TECHNICAL SPECIFICATION PROBLEM SHEET

SUBJECT: Table 3.3.7.1-1 of Technical Specification 3.3.7.1, pages
3/4 3-56, 3/4 3-57 and 3/4 3-58

Problem Title: RADIATION MONITOR

Attachment 1

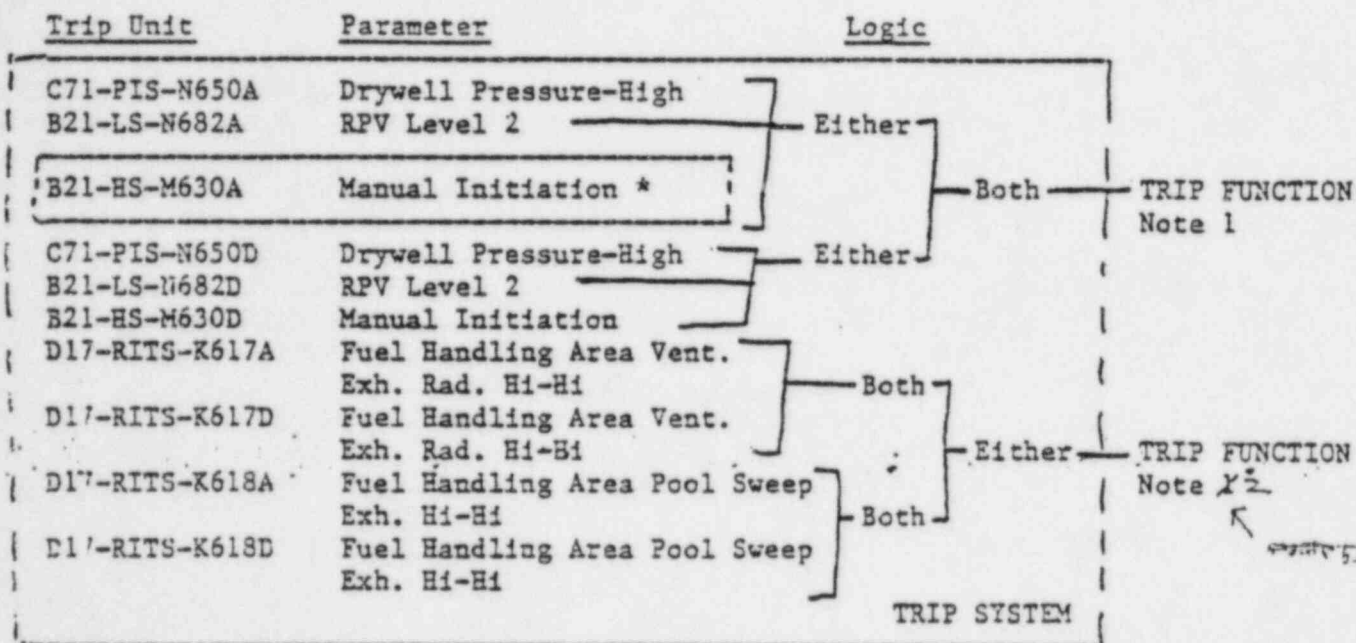
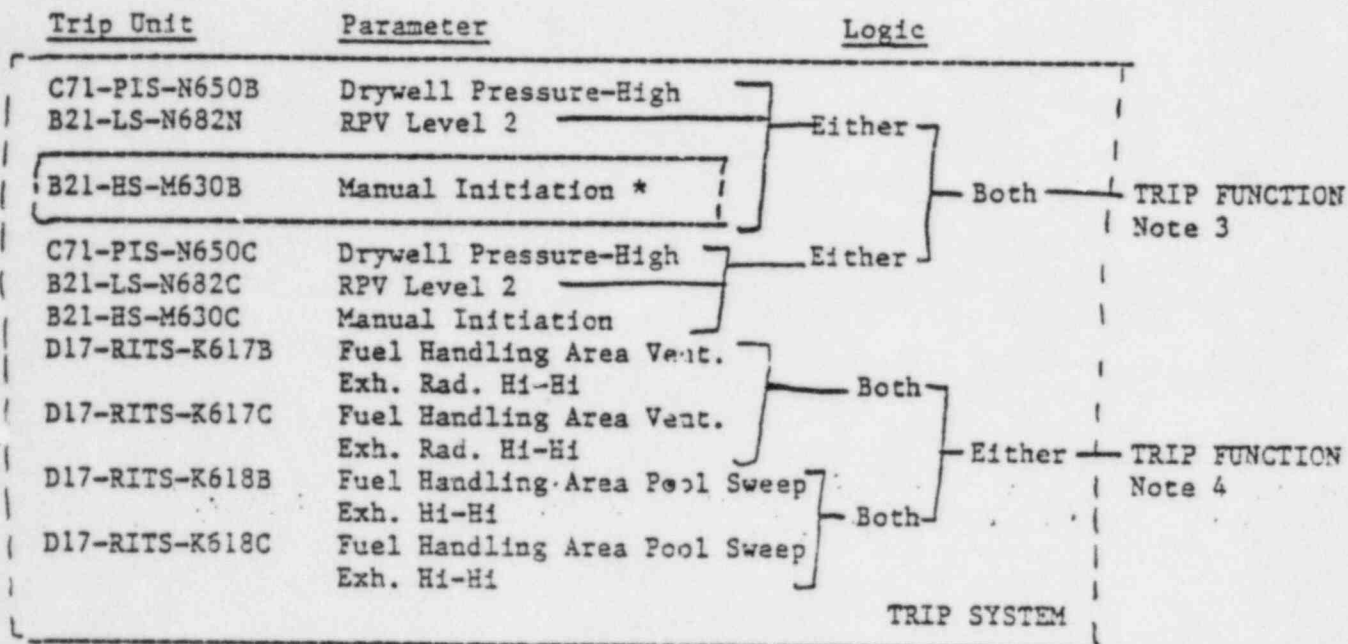
DISCUSSION: This change proposes to revise the Minimum Operable Channels for items 7, 8 and 9 of Table 3.3.7.1-1 and to revise their associated Action Statements. The affected items are:

Currently, 3 minimum channels operable are required for these items. This should be revised to 2/trip system for each item. In addition the b section of the Action statements for these items (Actions 74 and 75) should be revised such that 2 inoperable monitors per trip system, instead of 2 inoperable monitors, will cause entry into the b section and note h should be deleted from the table.

JUSTIFICATION: These revisions are required in order to reflect the design of the affected radiation monitors ^{system} (see attachment 1). The logic for each of these items consists of 4 monitors, with each monitor comprising one channel of a trip system. ^{The channels are grouped in pairs} ~~There are two~~ ^{separate trip systems} ~~trip systems~~ associated with ^{each} ~~each~~ ~~trip system~~ ~~consisting~~ ~~of~~ ~~2~~ ~~channels~~. Both channels ⁱⁿ a trip system are required to trip in order to initiate a trip function. The current requirement of 3 minimum operable channels does not apply to the instrumentation design ~~which only requires 2 monitors operable~~.

design and its associated two-out-of-two logic. By only requiring 3 monitors operable, it would be possible to have one trip system inoperable without entering the b section of the applicable Action statement. This would be inconsistent with the single-failure proof intent of the design of these monitoring systems. To make the specification consistent with the

~~the~~ design configuration a minimum of 2 operable channels per trip system is required. Revision of the applicable Action statements is required to prevent entry into the b section in the event that two channels in different trip systems are inoperable. This would be overly restrictive since two operable channels in different trip systems would still be available to provide monitoring and initiation of the trip function, if required. Note h should be deleted since it is no longer needed.

- ACTION 74 -
- a. With one of the required monitors inoperable, place the inoperable channel in the downscale tripped condition within one hour.
 - b. With two of the required monitors ^{in a trip system} inoperable, isolate the containment and drywell purge and vent penetrations within 12 hours.

- ACTION 75 -
- a. With one of the required monitors inoperable, place the inoperable channel in the downscale tripped condition within one hour.
 - b. With two of the required monitors ^{in a trip system} inoperable, initiate and maintain operation of at least one standby gas treatment subsystem within 12 hours.
